Access Compliance Report

Public Rights-of-Way

(Curb Ramps)

Intersection ID: 23547	Main Street: CASTLEGATE_DR	Cross Street: KNIGHTSWOOD_DR	Location: NE
ADA ID: 479F648D3DB7	Ramp Type: BlendTrans2	Initial Pass/Fail: Fail	Overall Compliance: No
Severity Score: 8.75			
Codes/Mitigation Info/Possible Solution		Field Measurements/Component Compliance

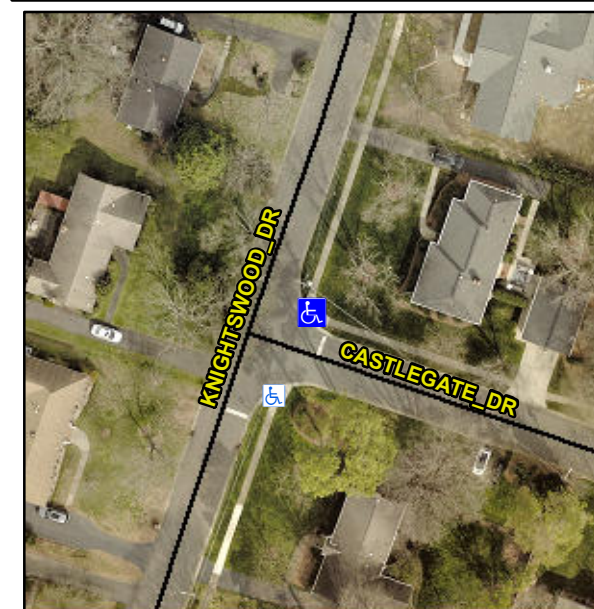
Not Found, R304.5.1

Compliance	Description	Data	Compliance	Description	Data
N/A	Ramp Length (in)	73.0	Yes	BlendTrans Slope (%)	4.2
No	Ramp Width (in)	47.0	Yes	BlendTrans XSlope (%)	1.0
N/A	Flare Type LT	N/A	N/A	Flare Type RT	N/A
N/A	Flare Slope LT (%)	N/A	N/A	Flare Slope RT (%)	N/A
N/A	Flare Traversable LT?	N/A	N/A	Flare Traversable RT?	N/A
N/A	Landing Length (in)	N/A	N/A	DWS Provided?	N/A
N/A	Landing Width (in)	N/A	N/A	DWS Contrast?	N/A
N/A	Landing Slope (%)	N/A	N/A	DWS Length (in)	N/A
N/A	Landing X Slope (%)	N/A	N/A	DWS Full Width?	N/A
N/A	Landing Curb? (Y/N)	N/A	N/A	DWS Offset (in)	N/A
N/A	Shared Landing?	N/A			
N/A	Gutter Ponding?	N/A	N/A	Gutter Slope (%)	N/A
N/A	Gutter Lip Ht (in)	N/A	N/A	Gutter X Slope (%)	N/A
N/A	Painted X Walk1?	No	N/A	Painted X Walk2?	No
	X Walk 1 Direction	To NW		X Walk 2 Direction	To SW
	X Walk 1 Width (in)	N/A		X Walk 2 Width (in)	N/A
	X Walk 1 Slope (%)	2.3		X Walk 2 Slope (%)	2.9
	X Walk 1 X Slope (%)	7.0		X Walk 2 X Slope (%)	3.1

N/A	Ramp inside XWalk1?	N/A	N/A	Ramp inside XWalk2?	N/A
	Road Slope (%)	1.5		Clear Space?	N/A
	Road X Slope (%)	6.2	N/A	Clear Space to XWalk (in)	N/A
N/A	Any Obstructions?	N/A	N/A	Storm Grate/Utility Hazard?	N/A
	Obstruction Type			Storm Grate/Utility Type	
		N/A			N/A
			Yes	Surface Condition? (G/P)	Good
			No	Curb Slope (%)	7.8

Remove & Replace Curb Ramp With Two New Directional Ramps or Equivalent.
